STATE OF NORTH CAROLINA
DEPARTMENT OF TRANSPORTATION

February 10, 2015

Subject: **Application Modification Request for USACE Individual Permit, Section 401 Water Quality Certification, Neuse Riparian Buffer Authorization and CAMA Major Development Permit** for the proposed improvement of US 17 from south of Belgrade at SR 1330/SR 1439 to the New Bern Bypass, in Onslow, Jones and Craven Counties. TIP No. R-2514 B, C & D.

PROJECT REFERENCE NO.	SHEET NO.
R-2514C	26A
R/W SHEET NO.	
ROADWAY DESIGN ENGINEER	HYDRAULICS ENGINEER
PRELIMINARY PLANS DO NOT USE FOR CONSTRUCTION	
ADDED 2/3/15	
DETOUR PERMIT DRAWING SHEET 1 OF 6

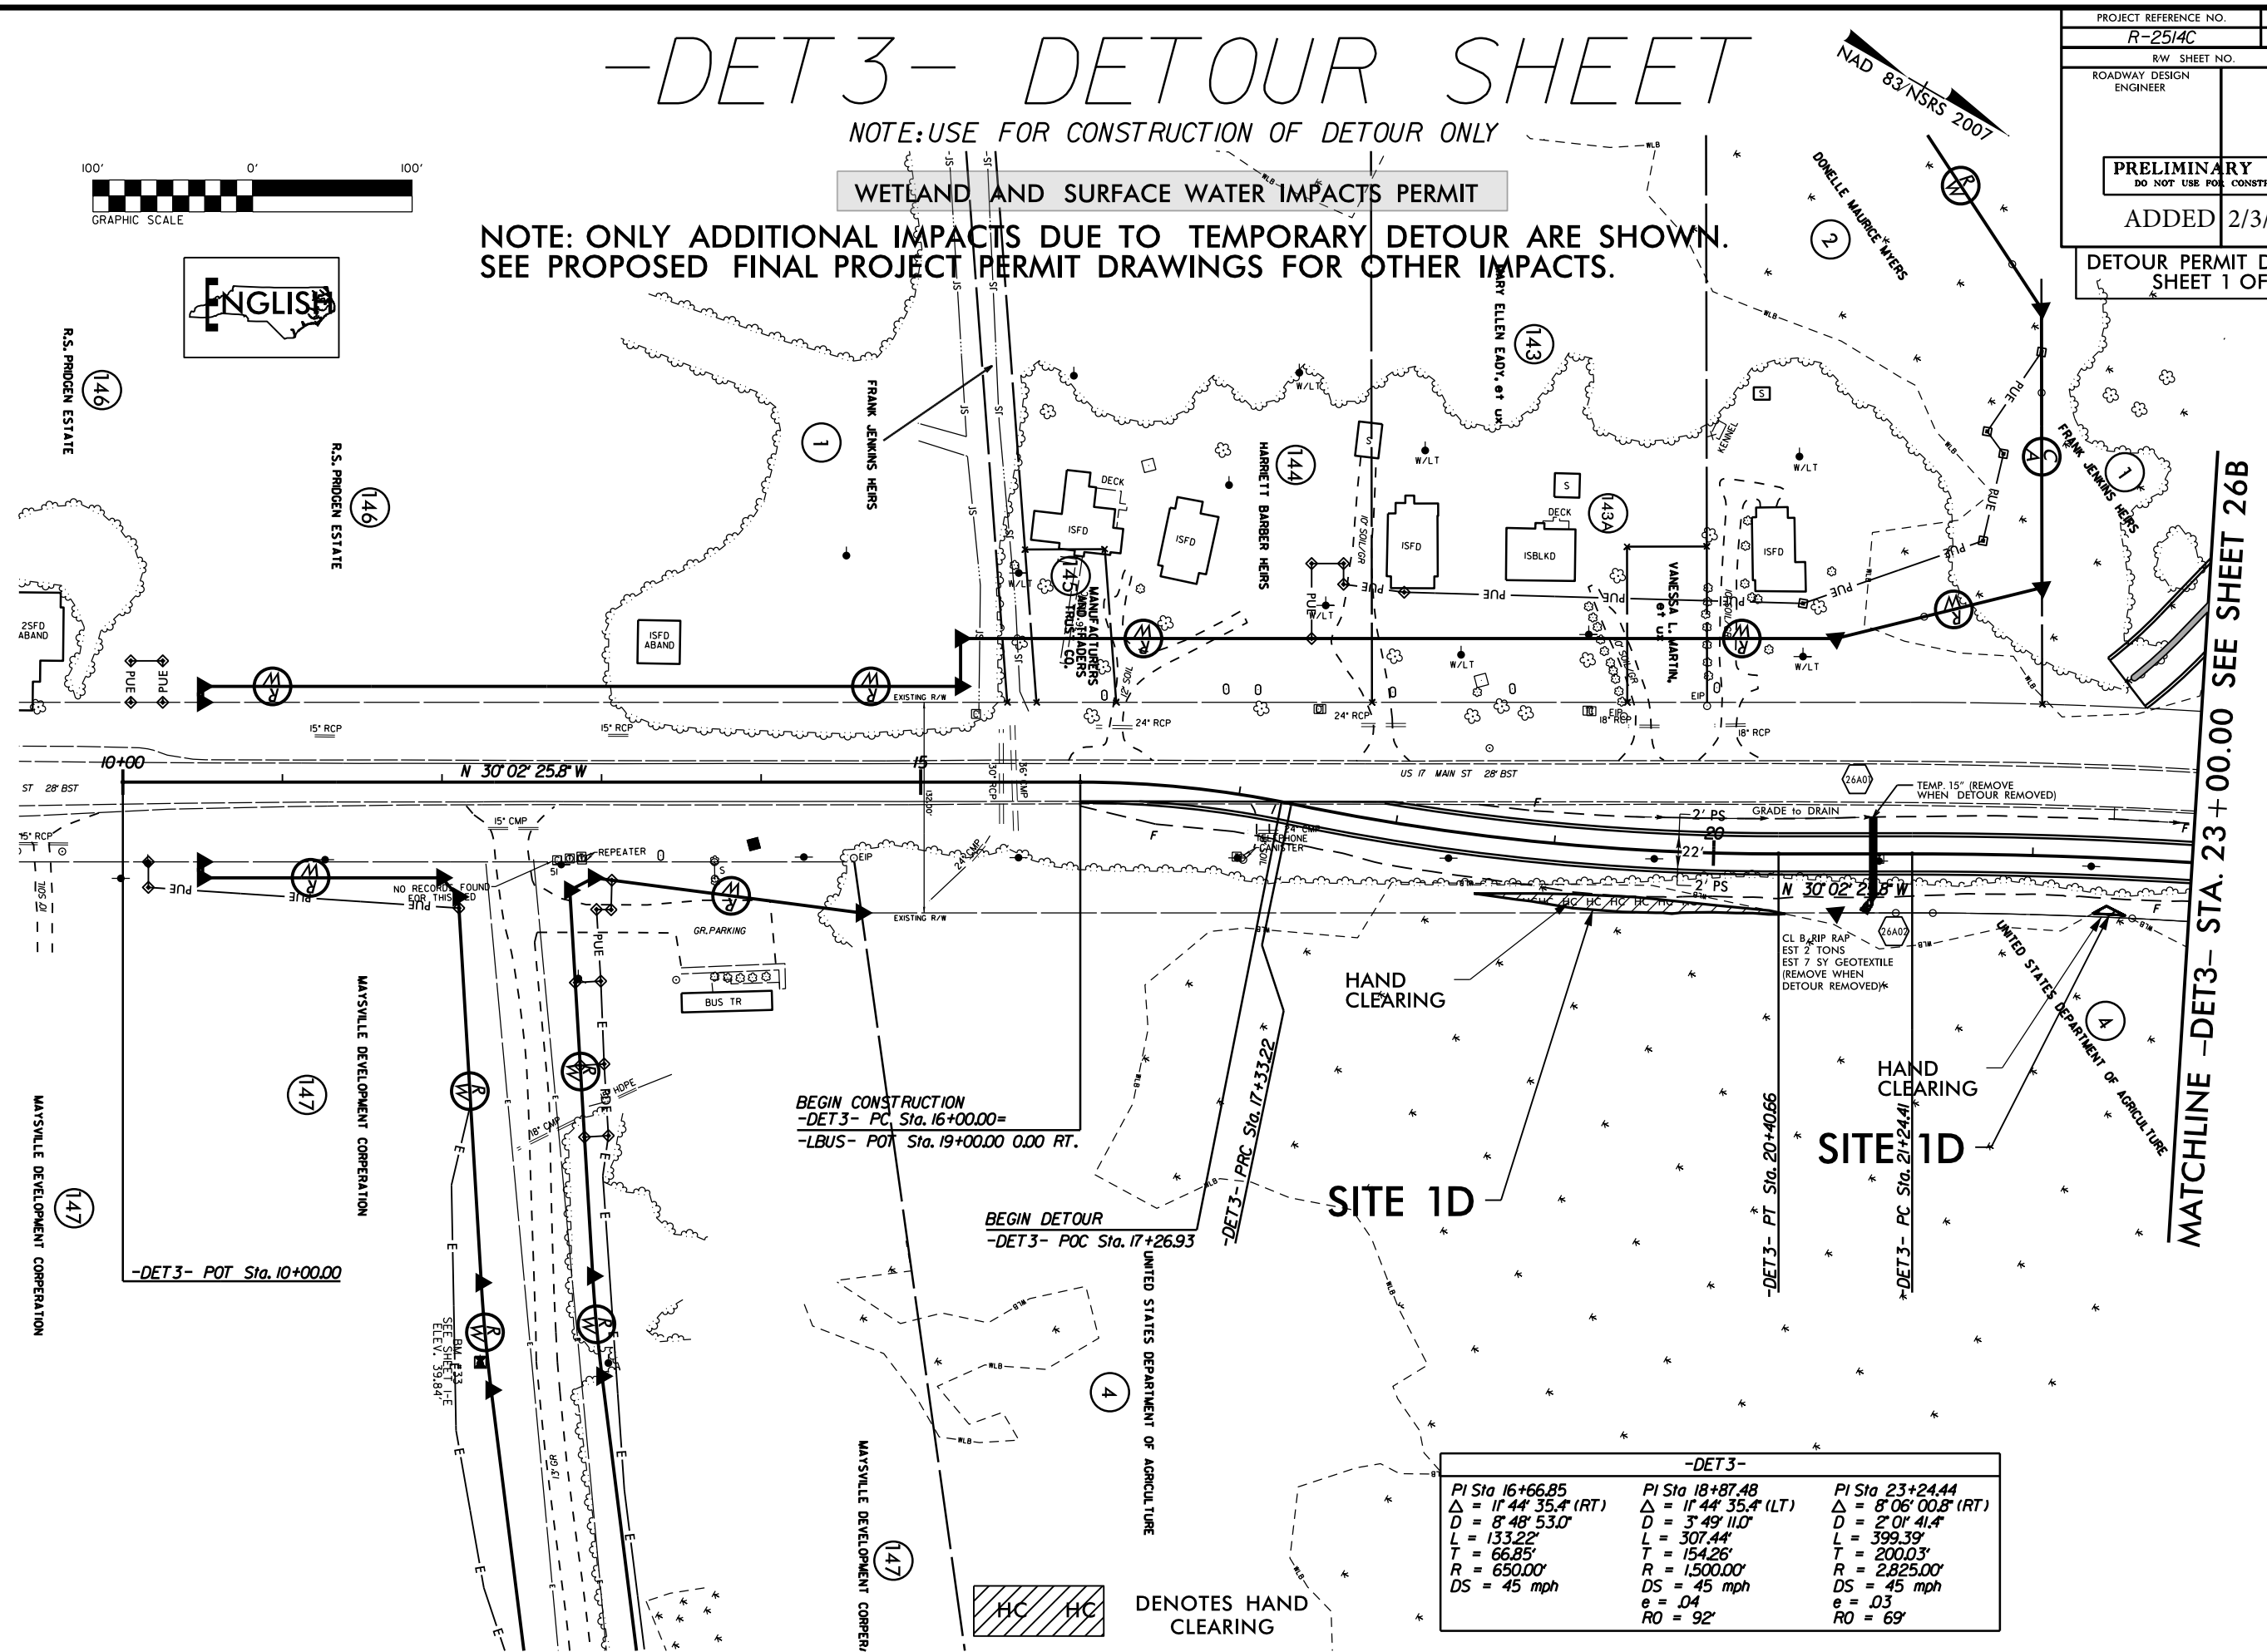
The revised drawings now include a temporary onsite detour associated with Section C of the project. The additional impacts for this detour are depicted in an attached set of drawings. The Site 1D shown in these drawings is an extension of Site 1 on Sheet 58 of 62 of the permit drawings. The Site 2D in the detour drawings is an extension of Site 2 shown on Sheet 7 of 62 of the permit drawings.

During phase I of construction, the proposed north bound lanes will be constructed while traffic is maintained on the existing alignment. During phase II, the temporary onsite detour will be utilized to carry traffic from the existing alignment to the newly constructed north bound lanes so the proposed southbound lanes, which follow the existing alignment, can be constructed. The additional temporary impacts are provided later in the revised impact tables.

BUFFER DRAWING
SHEET 2 OF 4

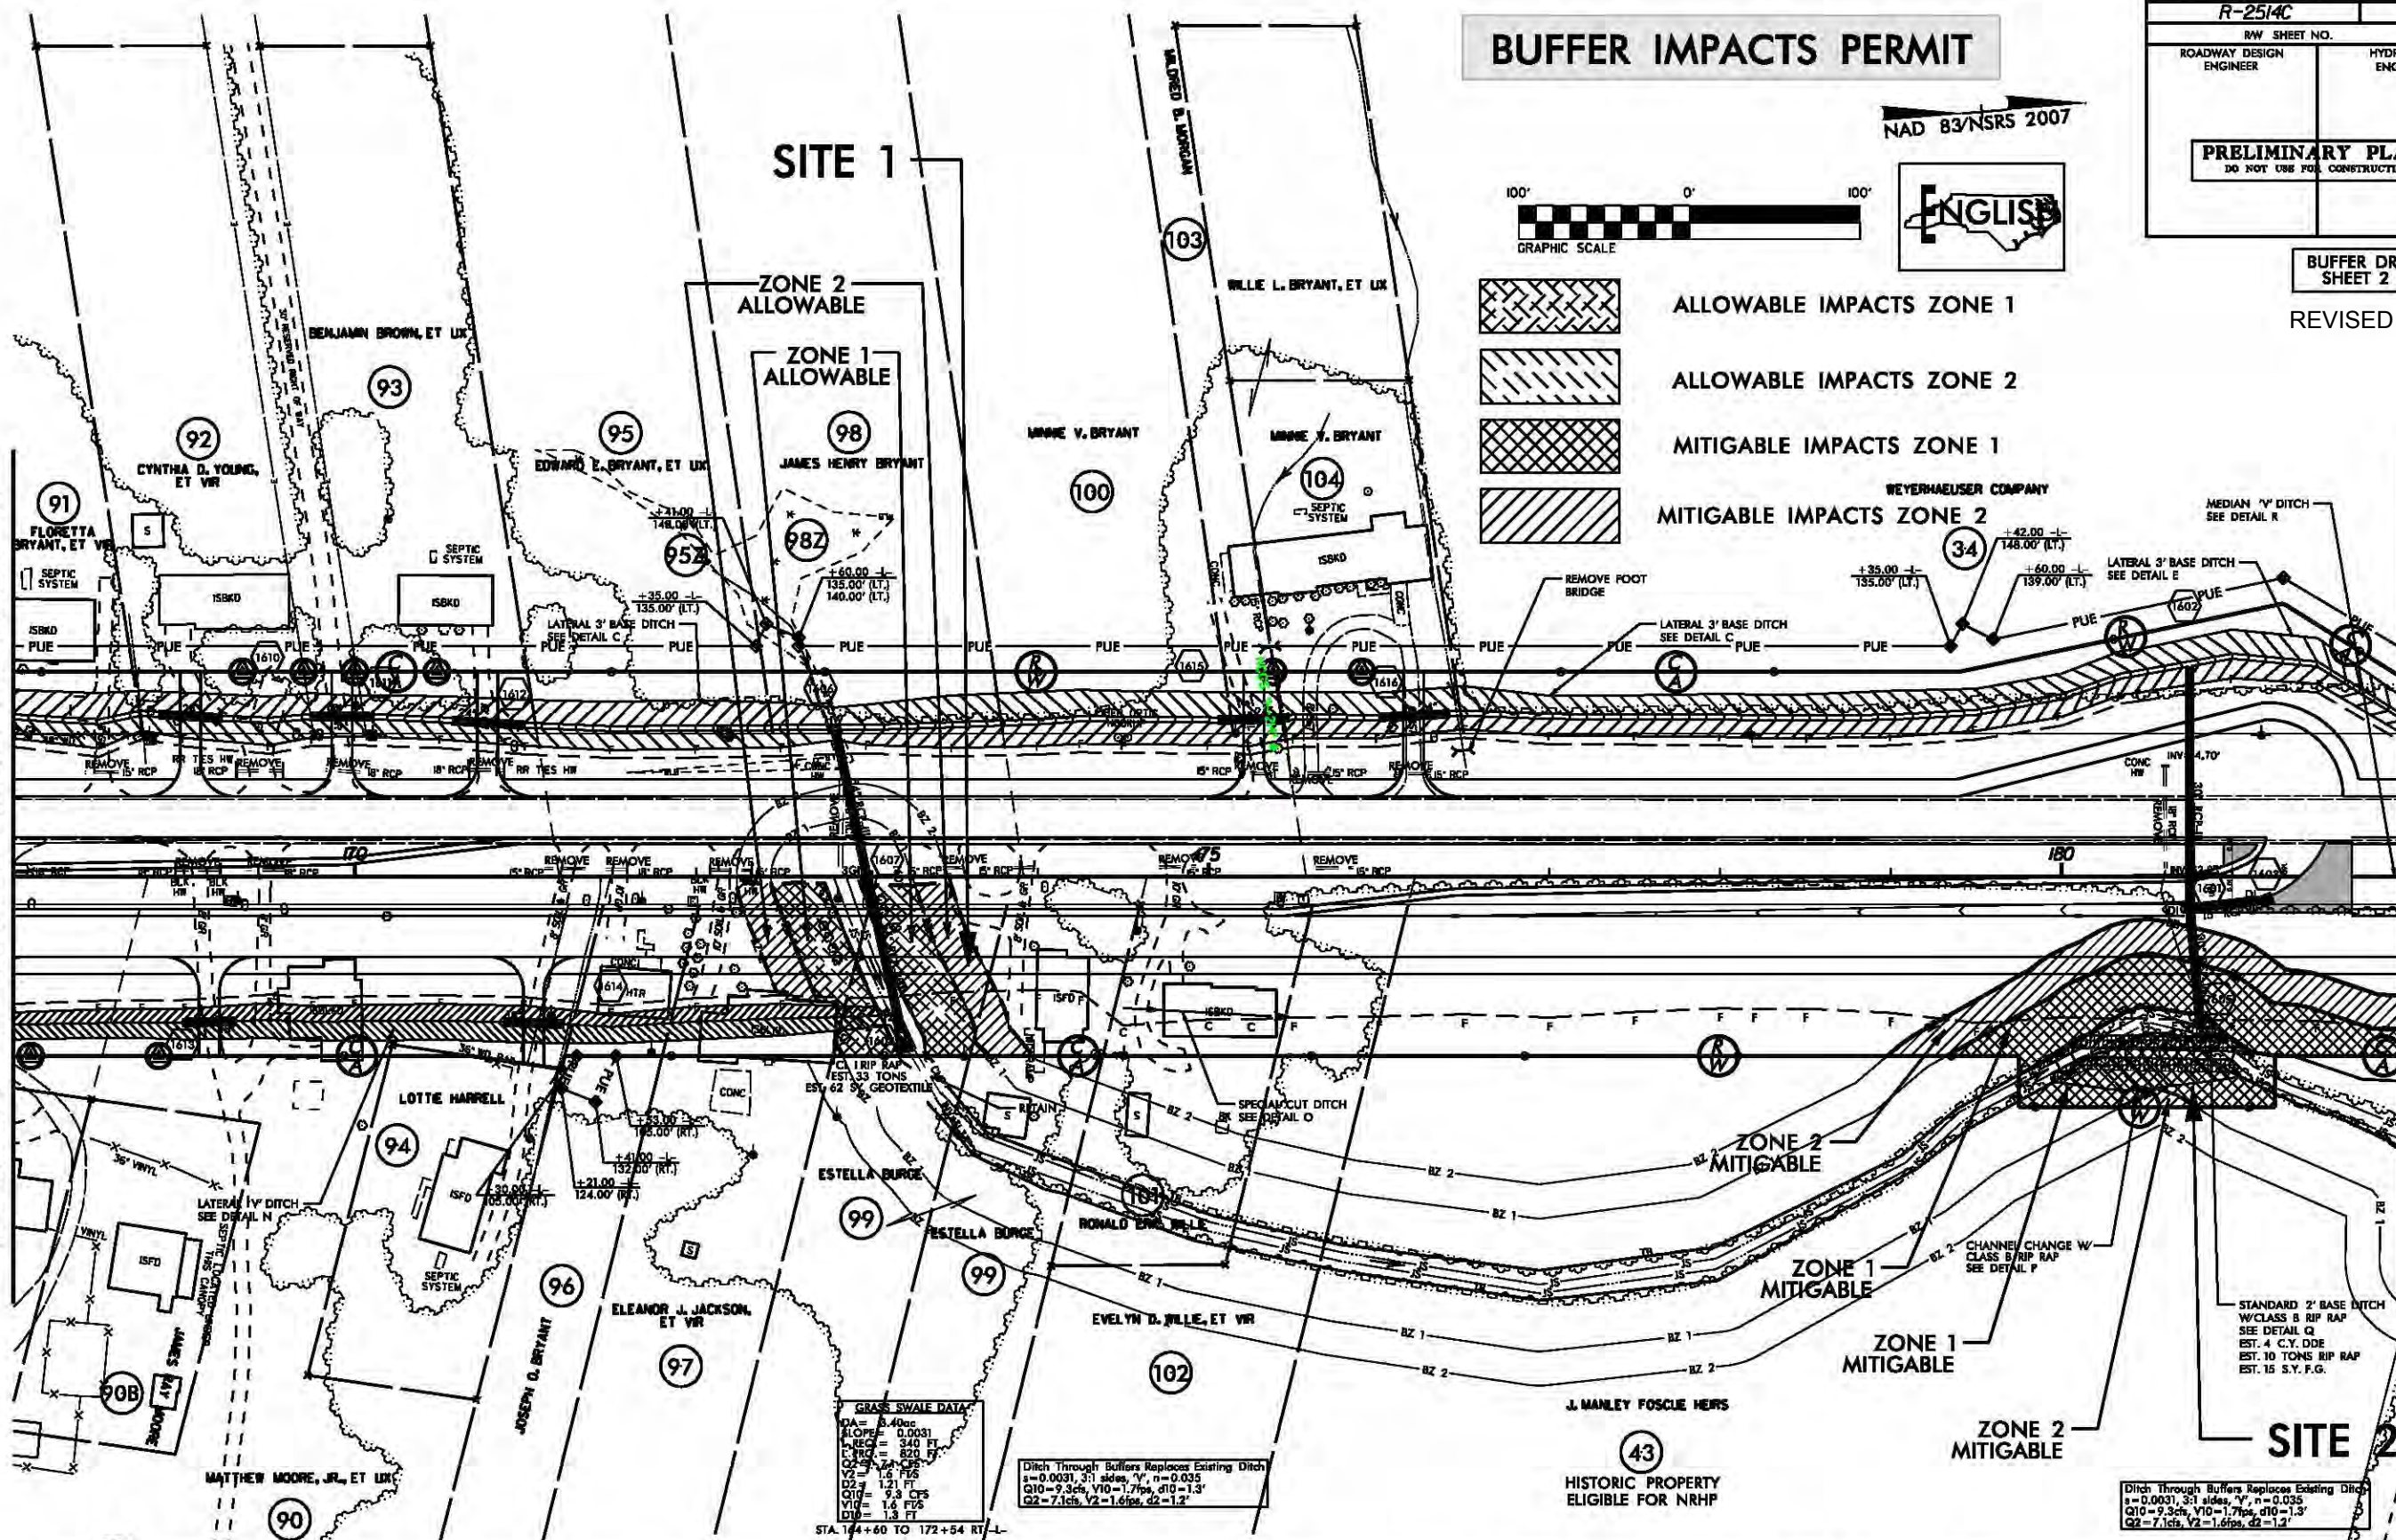
Comment 3: *Section C – The Stormwater Management Plan states that approximately 2/3rds of the project are in the Neuse River Basin, which is a riparian buffer basin. However, the plan does not include a swale summary table as does Section D. Please forward a summary table for this area.*

Response: A swale summary table for Section C is attached.
